RE: Comments regarding Gunnison Copper Project Class III Draft Underground Injection Control Permit

Technical Memorandum
Review of Underground Injection Control Permit and Application
Gunnison Copper Project

January 6, 2017

Figure 17: Figure 36 from Attachment A-2 showing the drawdown from the pump test at well NSH-015.

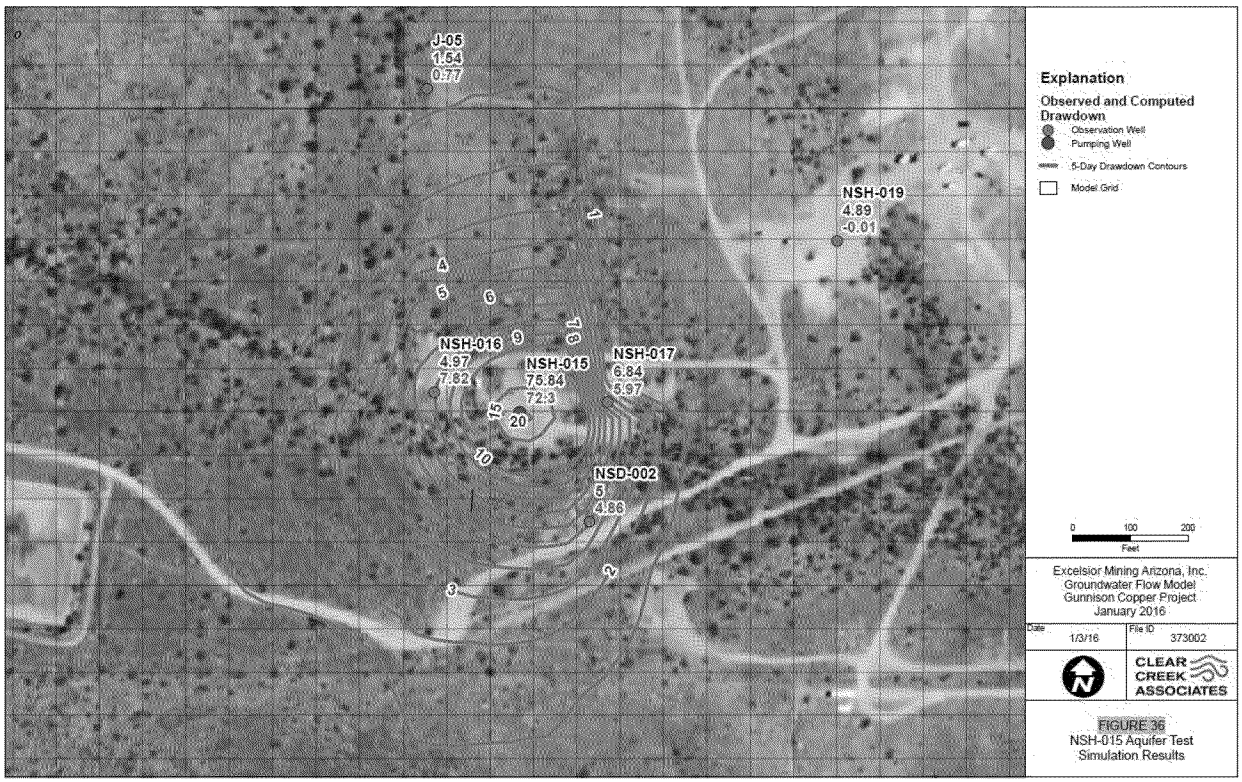
These results demonstrate future problems that will occur with the system. Injection of leachate into a fracture zone that does not have a collection well or a control well will allow flow to exit the system. Figure 17 shows however that there is likely an inappropriate model flow barrier between NSH-015 and NSH-019 since the observed drawdown, as noted 4.89 feet, occurs about 500 feet east of the simulated 1-ft drawdown contour. The simulated material

properties may not connect high K values to create an actual zone. The model cells are much larger than any fracture zone and the fracture intensity would depend on the observed fractures within the cell.
